Annex 69B

Interconnect characteristics

Figure 69B-2—Insertion loss and attenuation limits for 1000BASE-KX

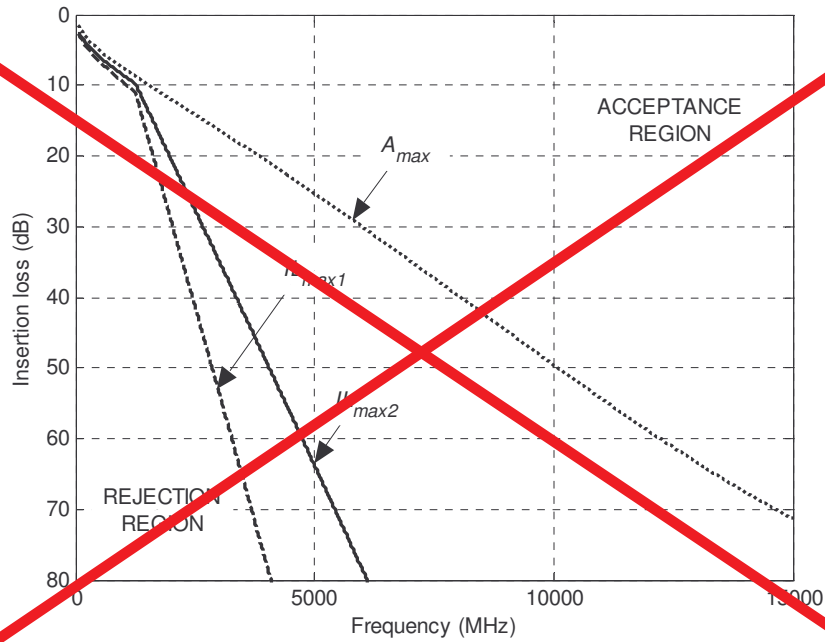
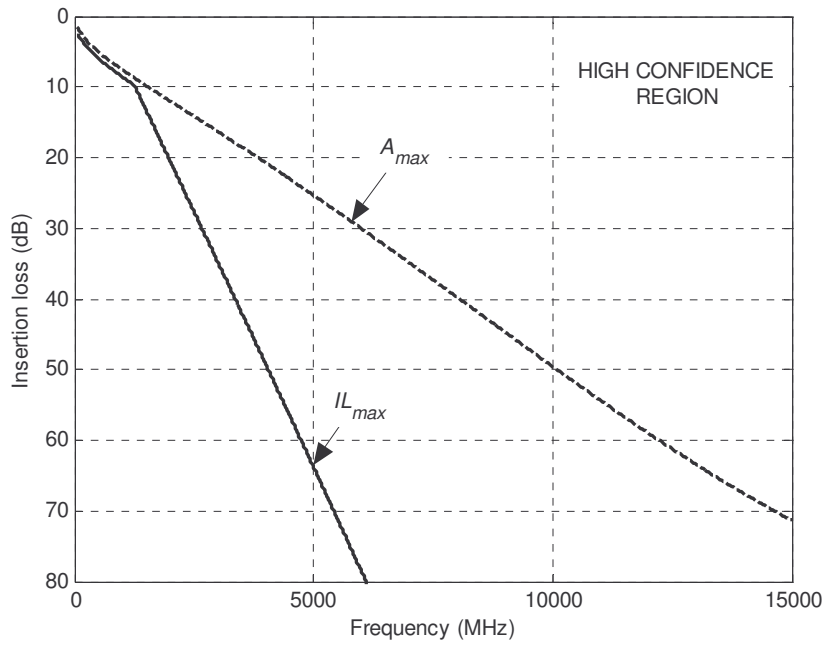
Insertion loss is defined as the magnitude, expressed in decibels, of the differential response measured from TP1 to TP4. It is recommended that the insertion loss magnitude, IL , be ~~less than or equal to~~ within the limit high confidence region defined by Equation (69B-7) and Equation (69B-8).

$$IL(f) \leq IL_{max1}(f) = A_{max}(f) + 1.1 + 9.0 \times 10^{-10} f \quad (69B-7)$$

$$IL(f) \leq IL_{max1}(f) = A_{max}(f) + 1.1 + 9.0 \times 10^{-10} f_2 + 2 \times 10^{-8} (f - f_2) \quad (69B-8)$$

$$IL(f) \leq IL_{max2}(f) = A(f) + 0.8 + 2.0 \times 10^{-10} f \quad IL(f) \leq IL_{max}(f) = A(f) + 0.8 + 2.0 \times 10^{-10} f \quad (69B-9)$$

$$IL(f) \leq IL_{max}(f) = A(f) + 0.8 + 2.0 \times 10^{-10} f_2 + 1 \times 10^{-8} (f - f_2) \quad (69B-10)$$

Figure 69B-5—Insertion loss deviation limits

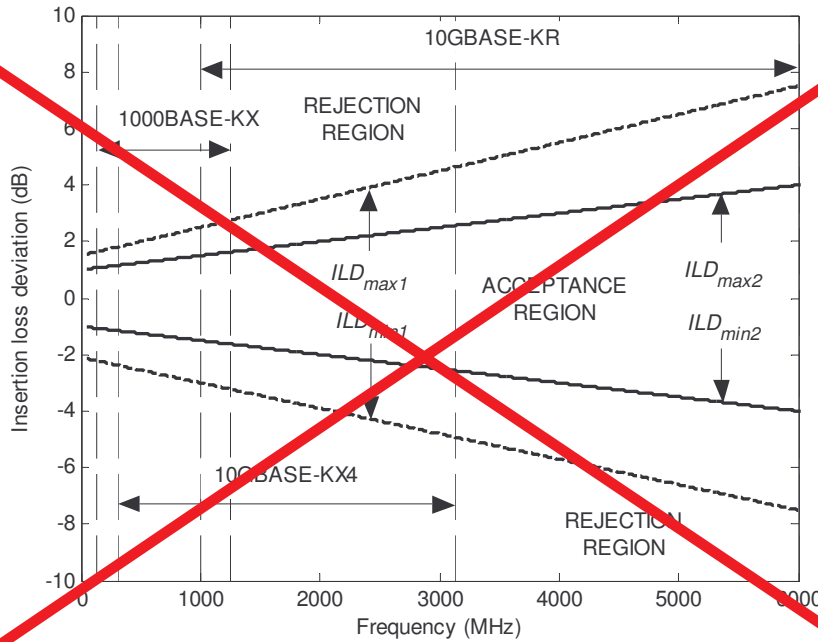
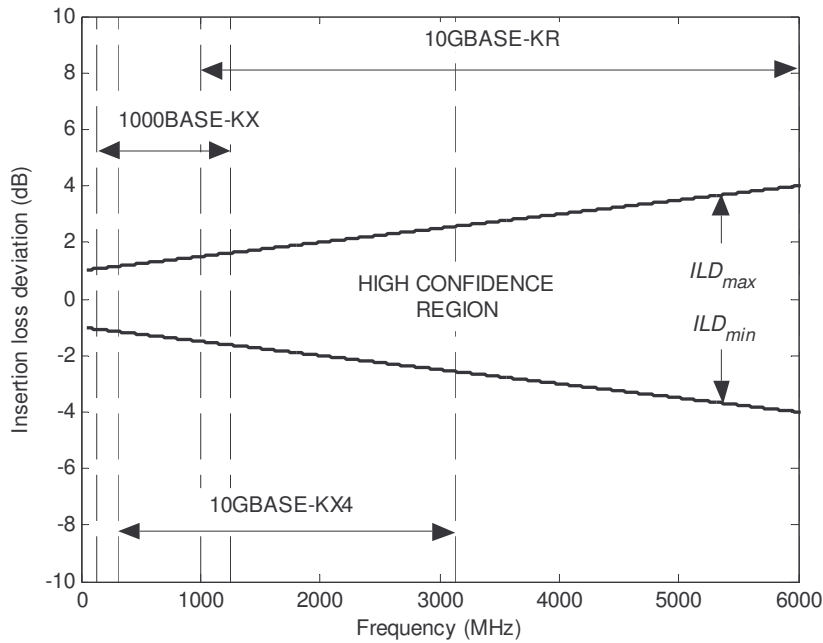
~~The insertion loss deviation, ILD , It is recommended to that ILD be constrained within the limits high confidence region defined by Equation (69B-10) Equation (69B-12) and Equation (69B-11) Equation (69B-13):~~

~~$$ILD(f) \geq ILD_{min1}(f) = -2.1 - 0.9 \times 10^{-9} f \tag{69B-10}$$~~

~~$$ILD(f) \leq ILD_{max1}(f) = -1.5 + 1.0 \times 10^{-9} f \tag{69B-11}$$~~

~~$$ILD(f) \geq ILD_{min2}(f) = -1.0 - 0.5 \times 10^{-9} f \quad ILD(f) \geq ILD_{min}(f) = -1.0 - 0.5 \times 10^{-9} f \tag{69B-12}$$~~

~~$$ILD(f) \leq ILD_{max2}(f) = -1.0 + 0.5 \times 10^{-9} f \quad ILD(f) \leq ILD_{max}(f) = 1.0 + 0.5 \times 10^{-9} f \tag{69B-13}$$~~

Figure 69B-6—Insertion loss to crosstalk ratio limit

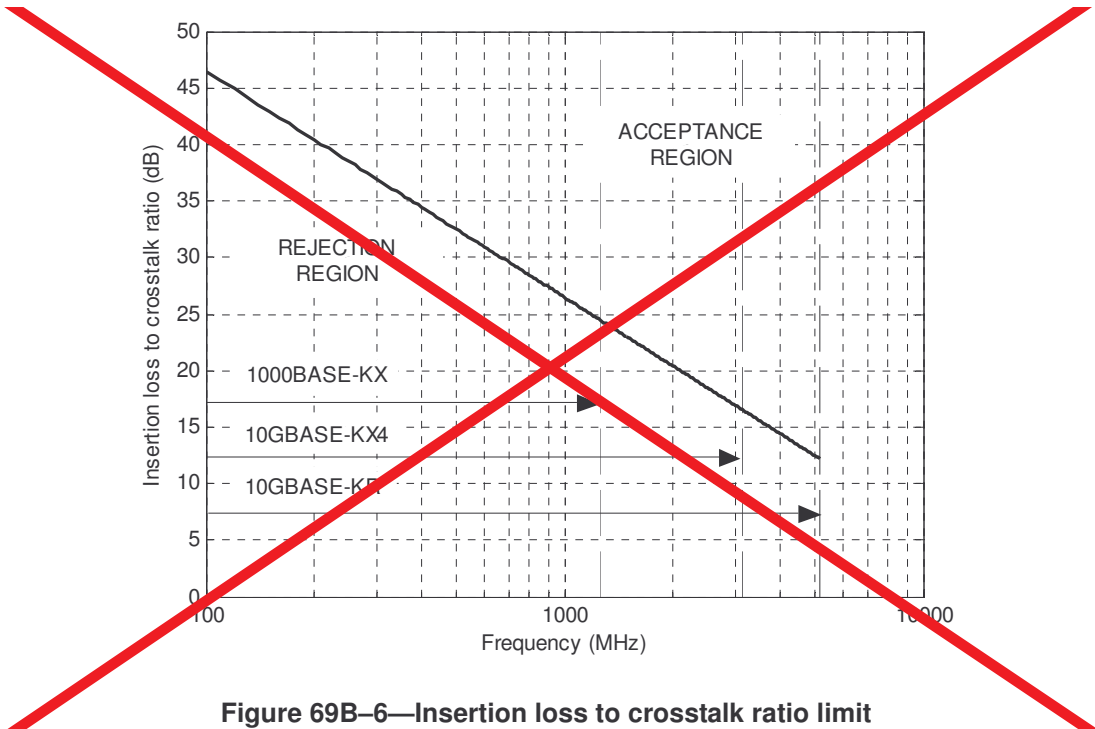
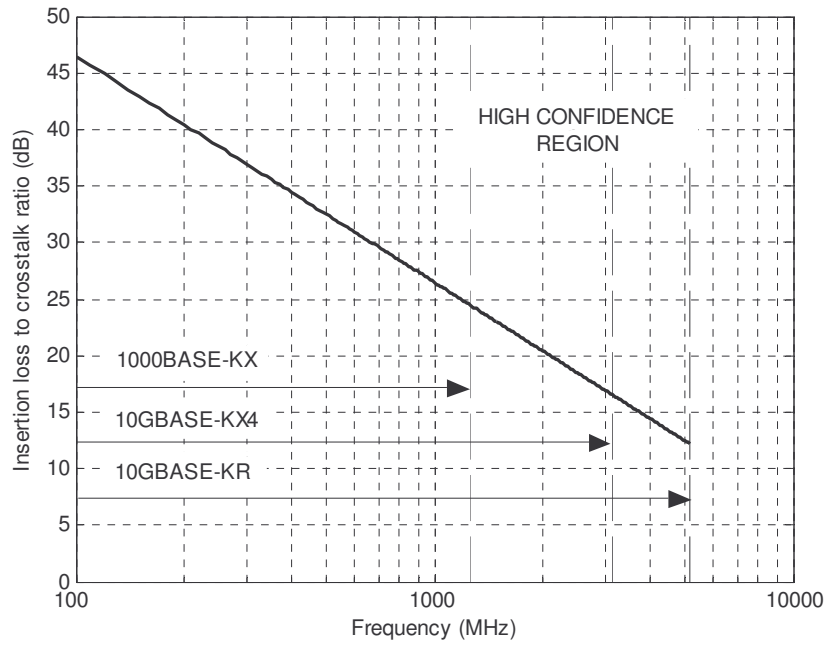
It is recommended that ICR_{fit} be greater than or equal to ICR_{min} as defined in Equation (69B-21).

$$ICR_{fit}(f) \geq ICR_{min}(f) = 12.5 - 20\log\left(\frac{f}{5 \text{ GHz}}\right) \quad (69B-21)$$
